TO: Mercedes-Benz Dealer Principals, General Managers, Sales Managers, Service Managers, Parts Managers	FROM: Thomas Brunner, Department Manager, Vehicle Compliance and Analysis, Engineering Services
RE:: Recall Campaign 2012100001 - Replace Refrigerant R1234yf with R134a, Model 231 (SL), Model Year 2013	DATE: October 26, 2012

Campaign No. 2012100001, October 2012

Replace Refrigerant R1234yf with Refrigerant R134a

Figure 1

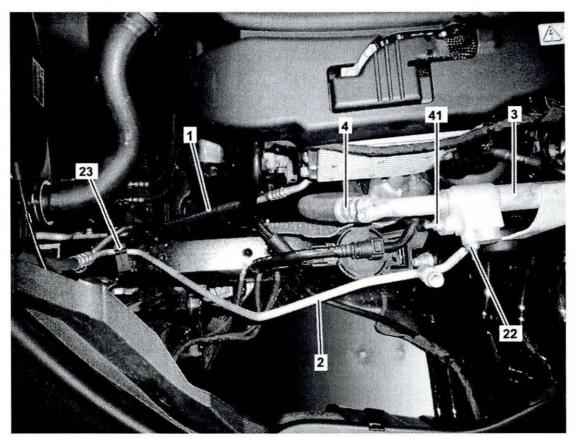
- High pressure refrigerant line
- Condenser refrigerant line
- Low pressure refrigerant line (to evaporator).
- 4. Low pressure refrigerant line (to compressor).
- 22 23 Condenser refrigerant line mounting clip
- 41 Nut
- 1. Remove nut (41, Figure 1).
  - > Torque nut (41) to 8 Nm when installing.
- 2. Disconnect refrigerant line (4, Figure 1) from refrigerant line (3).
- 3. Remove nut (22, Figure 1).
  - > Torque nut (22) to 8 Nm when installing
- 4. Disconnect condenser refrigerant line (2, Figure 1) from mounting clip (23).
- 5. Disconnect condenser refrigerant line (2, Figure 1) from refrigerant line (3).

Figure 2

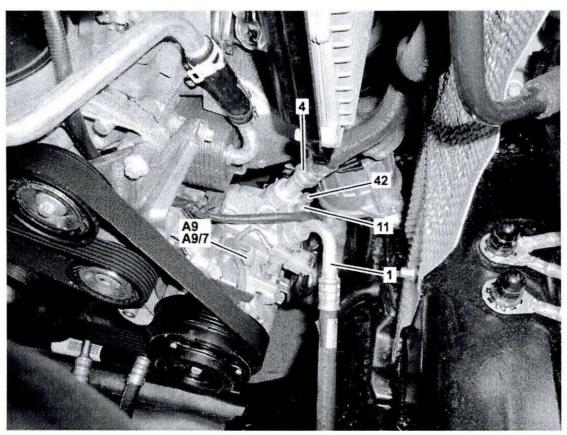
- 6. Remove lower front engine cover, refer to WIS AR61.20-P-1105RK.
- 7. Remove compressor refrigerant line bolt (42, Figure 2).
  - > Torque bolt (42) to 20 Nm when installing.
- 8. Disconnect compressor refrigerant line (4, Figure 2) from compressor (A9, A9/7).
- 9. Remove compressor refrigerant line (4, Figure 2).
- 10. Install new compressor refrigerant line (4, Figure 2) in reverse order.

Figure 3

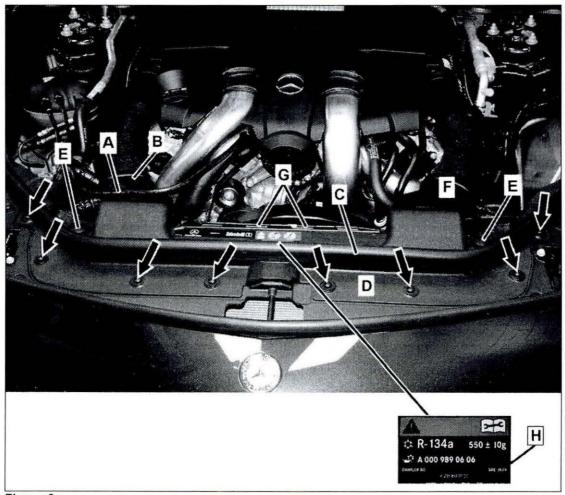
- 11. Remove radiator support/cover:
- Unclip coolant line (A, Figure 3) from air intake duct (B).
- Remove engine compartment seal (C, Figure 3) from radiator support/cover (D).
- Remove 2 radiator fasteners (E, Figure 3)
- Disconnect air intake ducts (B, F Figure 3) from radiator support/cover (D).
- Unclip hood release cable (G, Figure 3) from radiator (D).
- · Remove radiator support/cover screws (arrows, Figure 3).
- · Remove radiator support/cover (D, Figure 3).

Figure 7 (shown from front of vehicle, behind radiator grill)

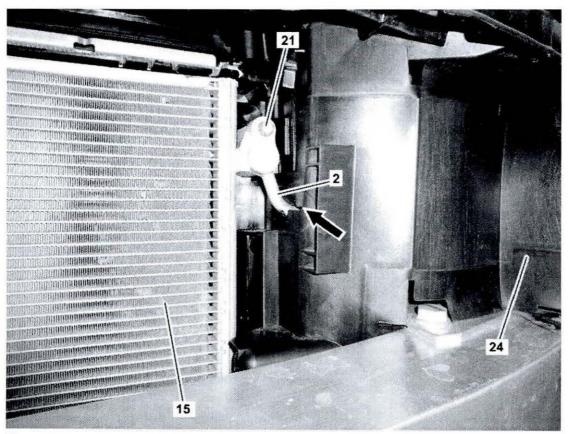
Route condenser refrigerant line (C, Figure 6) out through opening (arrow, Figure 7) in radiator side shroud (24, Figure 7) and remove from engine compartment.
